## Mack Anthem - Hood Latch Striker Rattle

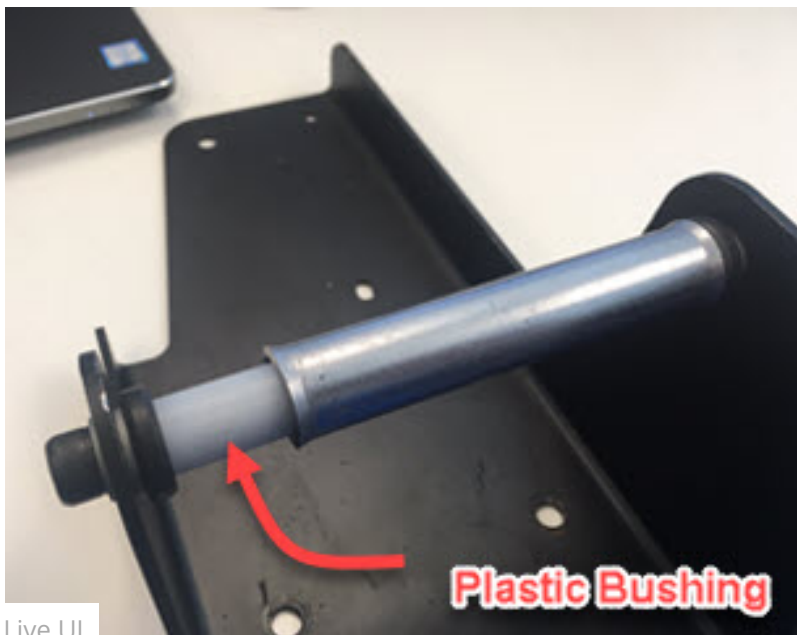
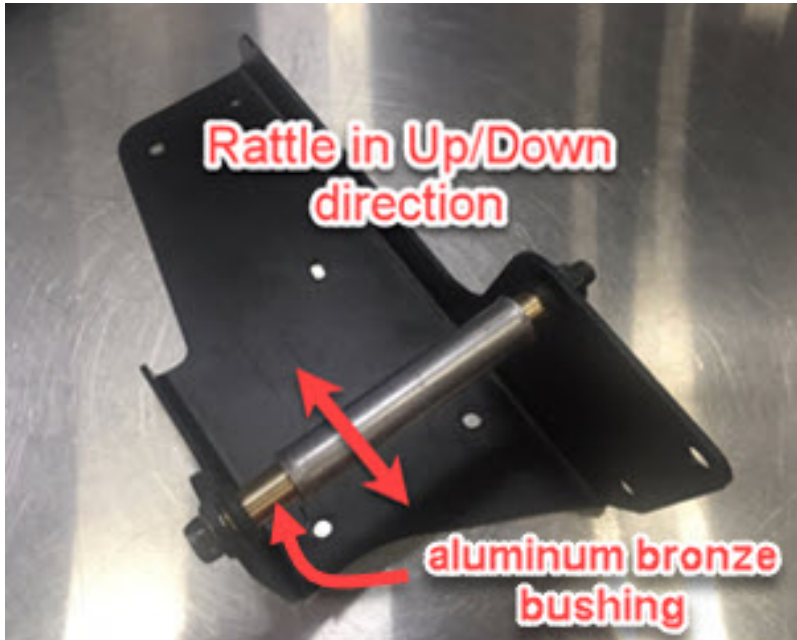
For Mack Anthem units with the hood striker rattle complaint, an updated hood latch striker design has been developed. The new design features a plastic bushing rather than the aluminum bronze bushing. To correct this issue replace both striker pins using kit P/N **23799066**. Latch assemblies manufactured after November 16th, 2020 will contain the updated striker pin.

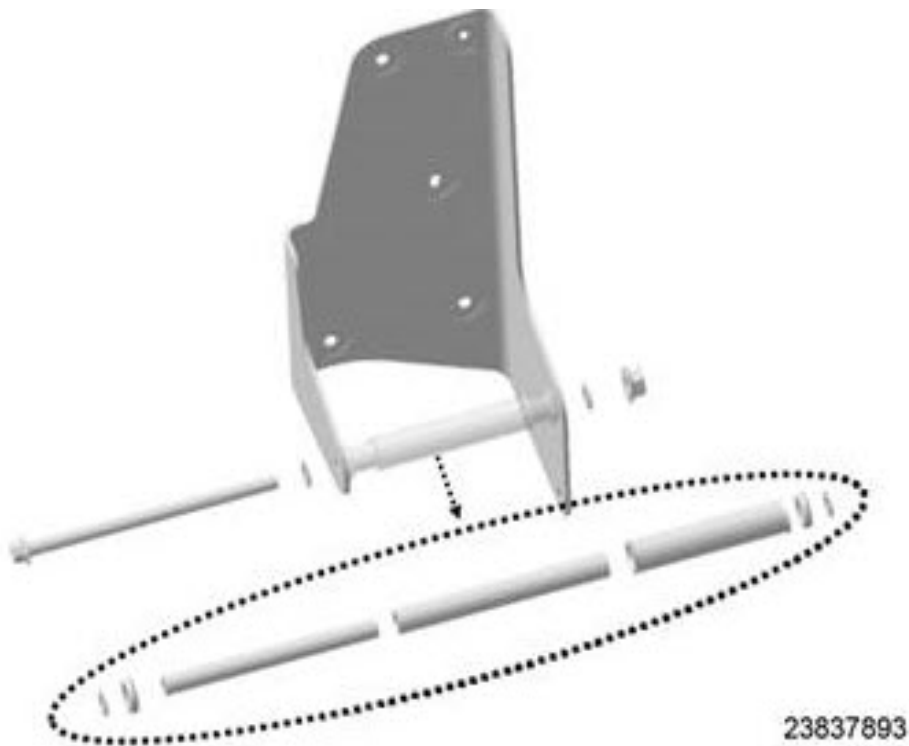
Assemble the components as shown below. Ensure that the bolt is installed in the direction shown. It is critical to **TORQUE THE NUT TO  $20 \pm 3$  Nm, THEN  $120 \pm 5$  DEG (1/3 OF A TURN)**.
